ADDENDUM 01

This addendum is considered to form part of the contract document issued for this Request for Quotation. Its content precedes previously issued documents in case of conflicting information.

E-000

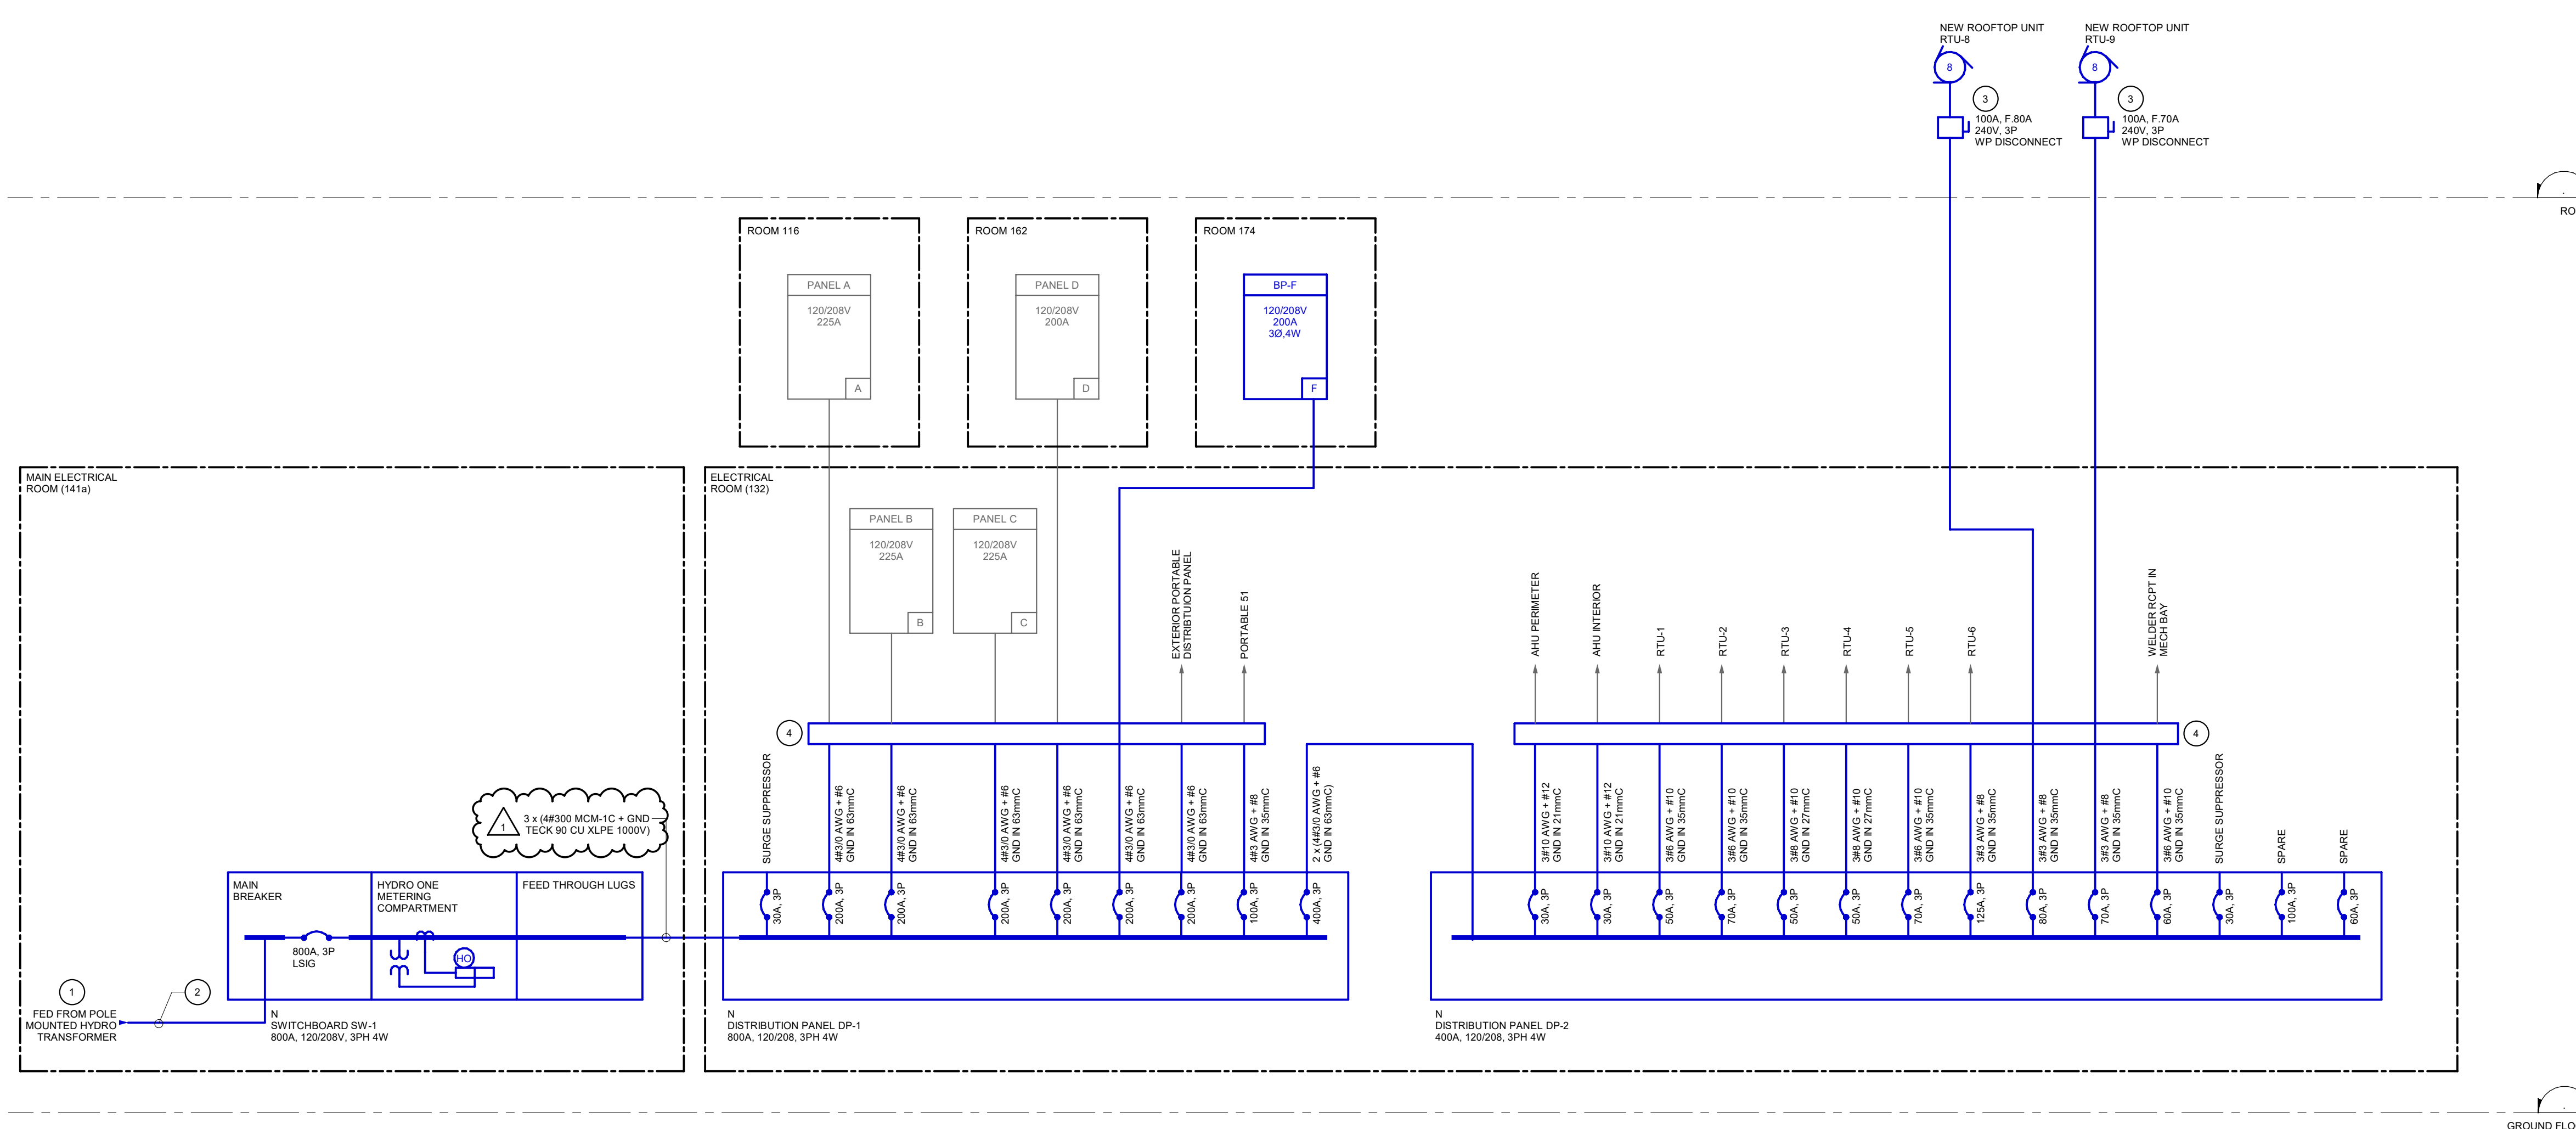
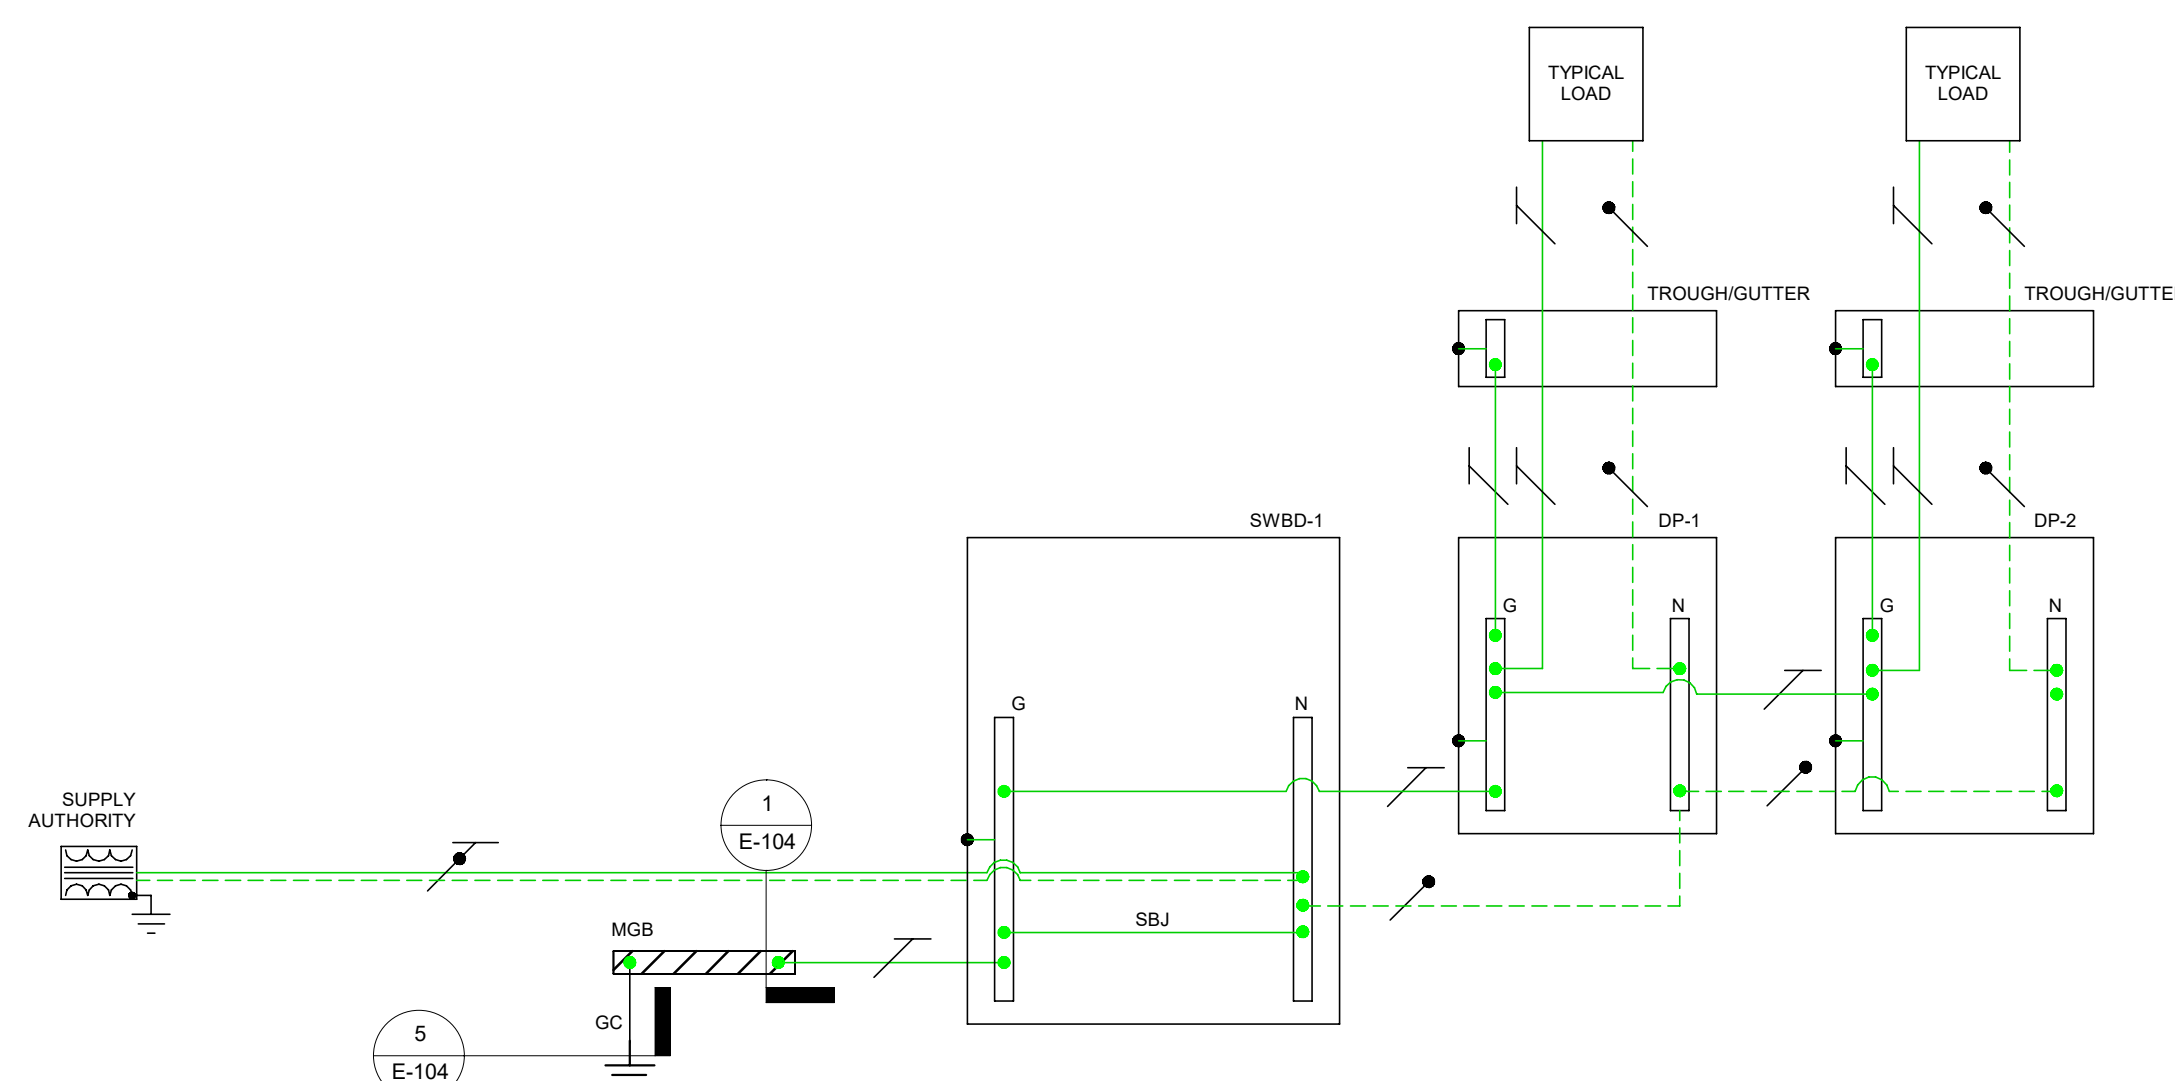
2.1 Drawing E-000

- Refer to drawing for revised details 2 & 3.
